STATE OF NEW YORK
OFFICE OF GENERAL SERVICES
DESIGN AND CONSTRUCTION GROUP
THE GOVERNOR NELSON A. ROCKEFELLER
EMPIRE STATE PLAZA
ALBANY, NY 12242

ADDENDUM NO. 2 TO PROJECT NO. 42534-E

**ELECTRICAL WORK
UPGRADE ELECTRIC DISTRIBUTION SYSTEM, SITEWIDE
GREAT MEADOW CORRECTIONAL FACILITY
ROUTE 22
COMSTOCK, NY 12821**

October 29, 2014

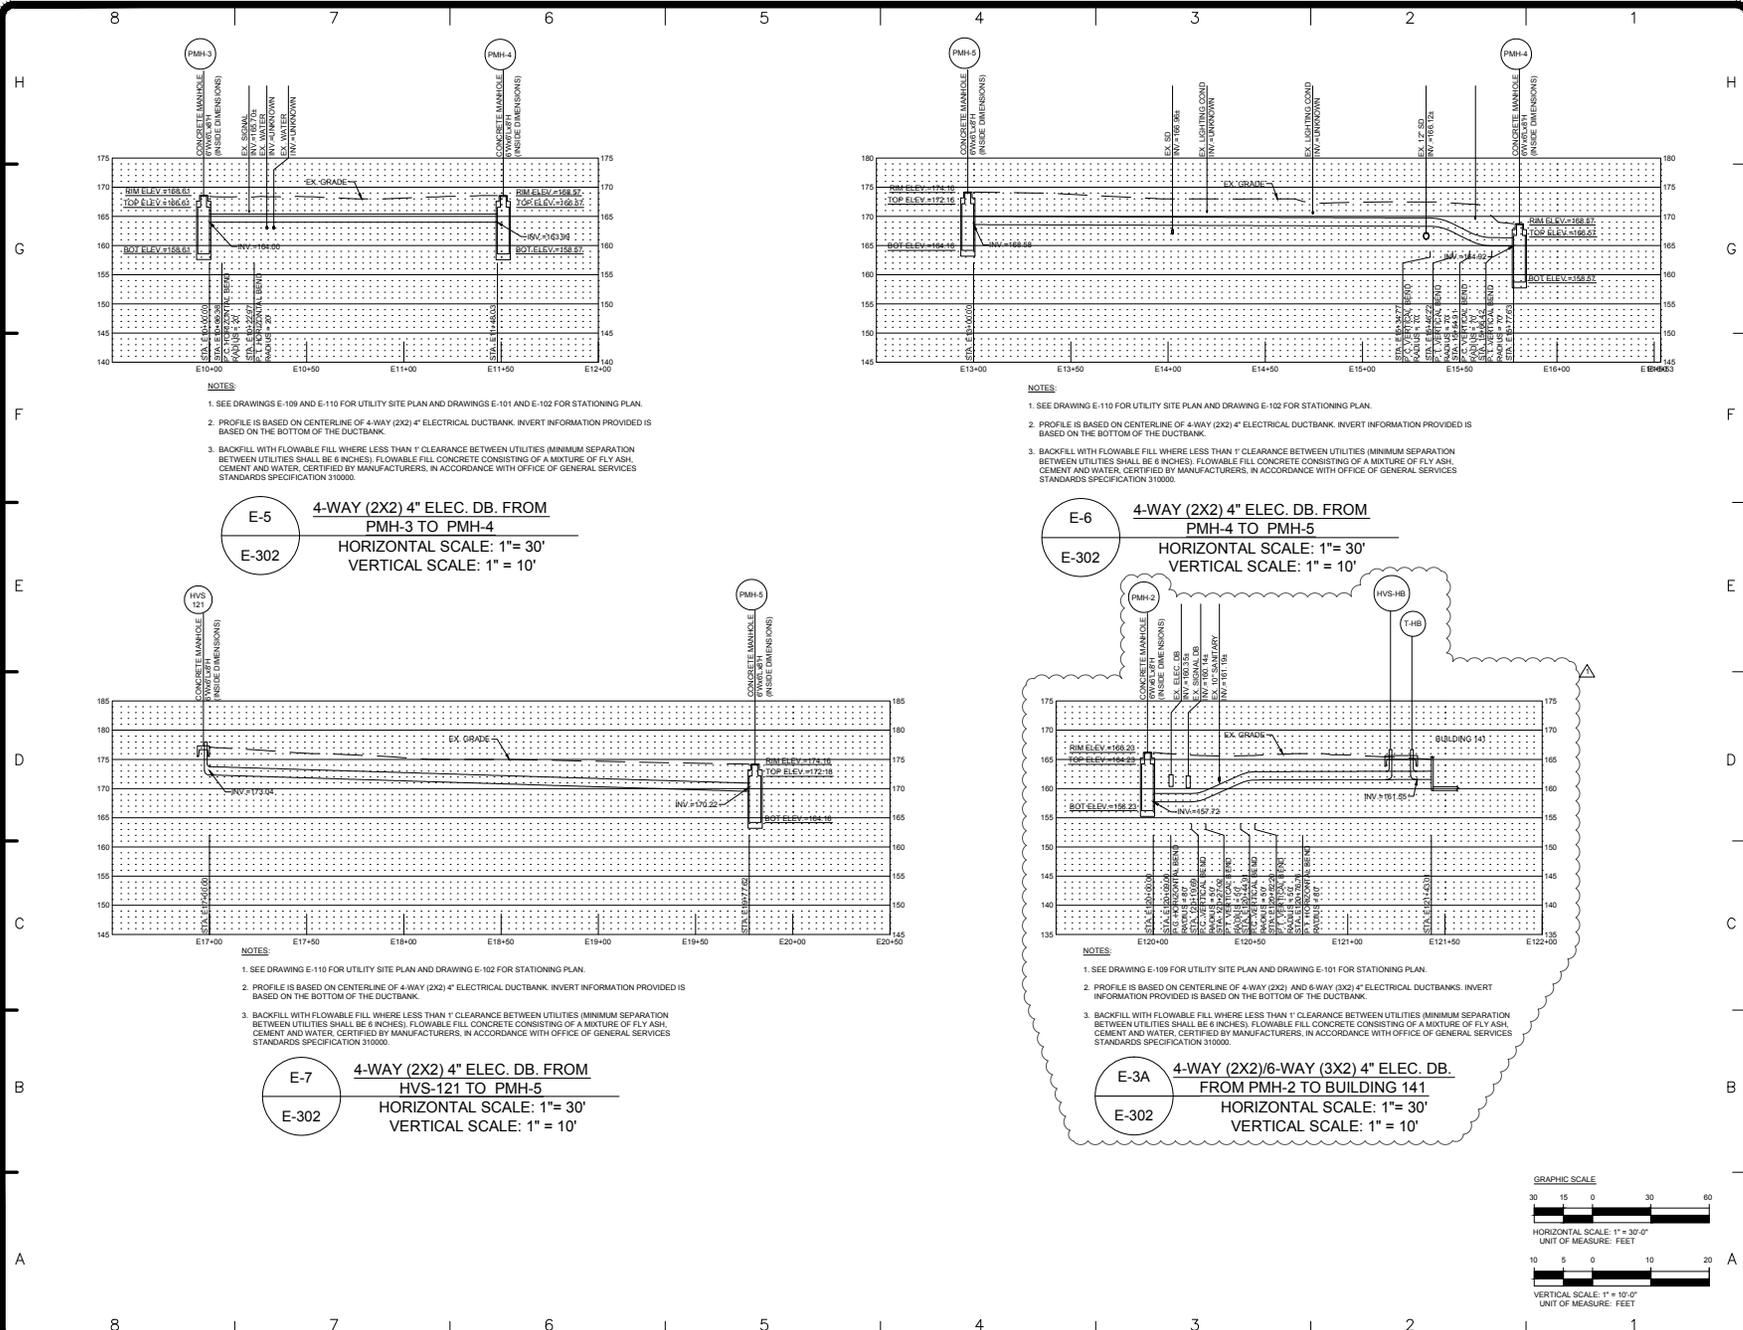
7. Addendum Drawing:
- a. Drawing No. SK-HVS, dated “10/27/14” accompanies this Addendum and forms part of the Contract Documents.
8. Revised Drawings:
- a. Drawing Nos. E-115, E-302, E-307, E-308, E-309, E-310, E-311, E-312, E-313, E-314, E-315, E-316, E-401B, E-504, E-513, E-514 and E-602, noted “10/27/14 ADDENDUM NO. 2” accompany this Addendum and supersede the same numbered originally issued drawings.
